SECTION 4:
IR SPECIALIST REPORTS

Enhance
URBAN PLANNING

239 & 241 Boundary St, Coolangatta

Response to Information Request (Development Application) MCU/2023/15
239 Boundary Street, Coolangatta, QLD, 4225

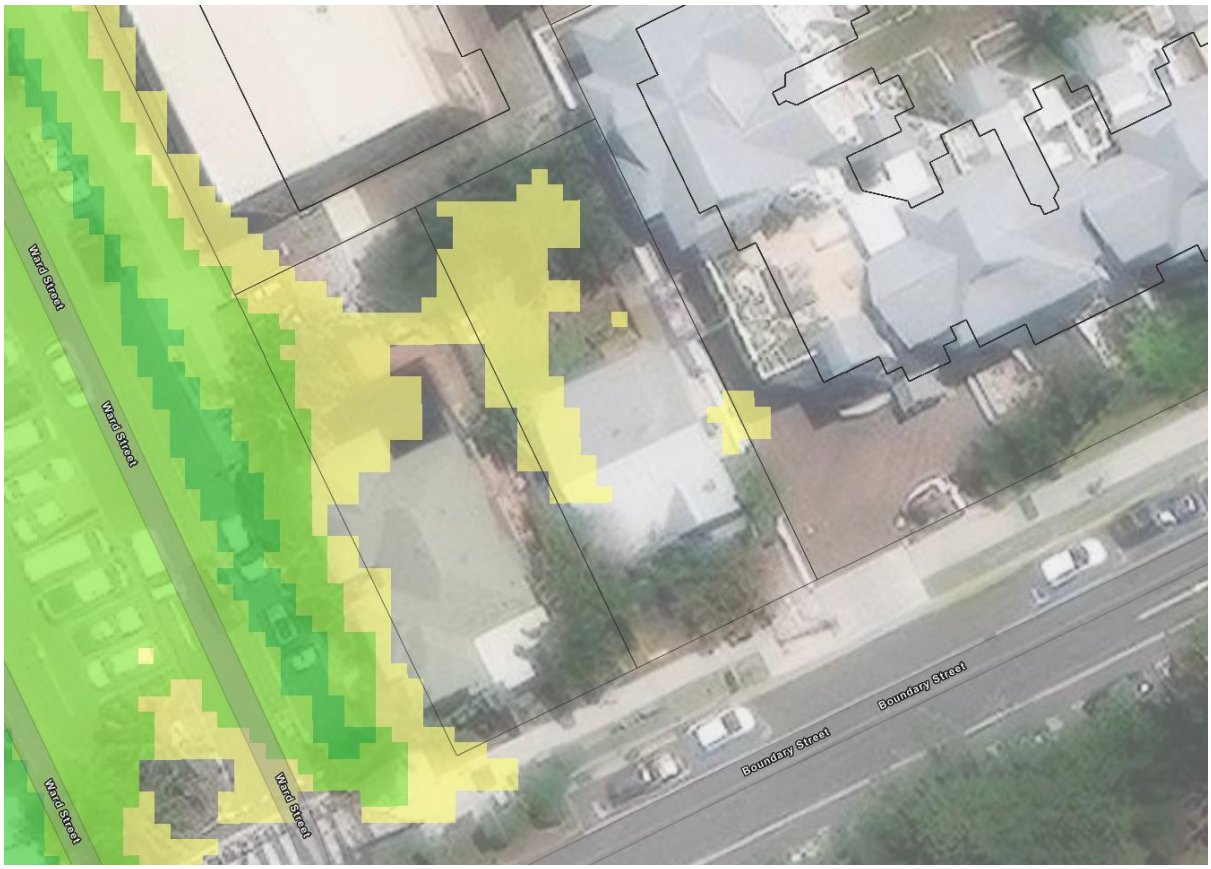
The applicant is requested to submit the revised flood storage capacity calculations showing the listed items and no loss of flood plain storage has occurred as a result of the earthworks. It is requested to include the following:

c) The Developed Flood Storage Layout Plan depicted in Figure 1 below, does not make it clear how the highlighted area would contribute to obtain the necessary flood storage capacity in a 1% AEP event. Also demonstrate how the floodwaters will stop entering the basement after filling to a depth of 400mm or above (up to 600 mm) in order to achieve requisite flood storage capacity. The applicant is requested to address and amend the previously submitted architectural plans by clearly showing the passage of flood water to basement or other designated area without impacting the transition of vehicle movement in and out of basement.

d) The Developed Flood Storage Layout Plan depicted in Figure 1 below does not consider reasonable grades and changes of grade to ensure vehicles can safely drive through this area for the long periods when flooding does not occur.

e) The Developed Flood Storage Layout Plan depicted in Figure 1 below appears to be in the wrong location. This should be positioned as far from the access ramp as possible so that cars in the unflooded area do not have to drive through floodwaters to exit the garage thereby placing themselves at risk.

Please refer to the updated flood code response report, which has been updated in accordance with the above RFI. Please refer below for specific items:

c) Please refer to the revised flood code response reporting. Plans detailing how flood waters will enter the basement and how basement flood water depths will be managed are provided within.
d) The intent of this RFI item is unclear, the flood storage calculations consider the basement carpark grades provided by the architect at 1:20 maximum grades.
e) The flood storage location has been adjusted to be on the other side of the development site to be at the lowest point of the carpark.
f) Files have been provided as part of the information request package.
